ADDENDUM NUMBER 1

BID TITLE: PROPOSED SEAWALL AND STAIRWAY REHABILITATION PROJECT

DORCHESTER STREET SEAWALL REHABILITATION PLAN

PRECAST CONCRETE SEAWALL UNIT
 NOT TO SCALE

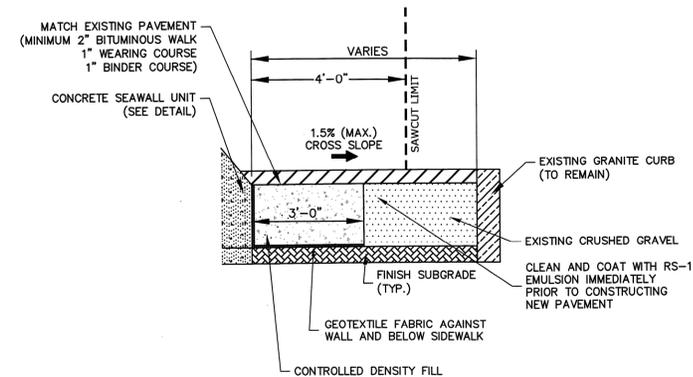
Q12: The detail on sheet 3 of 7 shows the dimensions for the Precast Concrete Seawall Unit. Currently, the dimensions given do not work as shown. Please clarify the dimensions so that form molds can be accurately designed.

Q19: Has the Sea Wall Block Detail shown on page 3 of 7 of the contract plans been used on previous projects in the city?

A12: The dimensions of the precast seawall block unit have been revised on sheet 3 of 7.

A19: The detail depicted on the sheet 3 of 7 is unique to this project. The bidders are referred to the revised sheet 3 of 7 for updated dimensions.

1.	3/5/13	REV PRECAST SEAWALL DIMENSIONS
A.	02/2013	ISSUED FOR BIDDING
Mark	Date	Description
PROJECT NO:	Q0020	
FILE:	Q0020_SEAWALLS.dwg	
DRAWN BY:	KAM	
CHECKED:	GMM	
APPROVED BY:	DAM
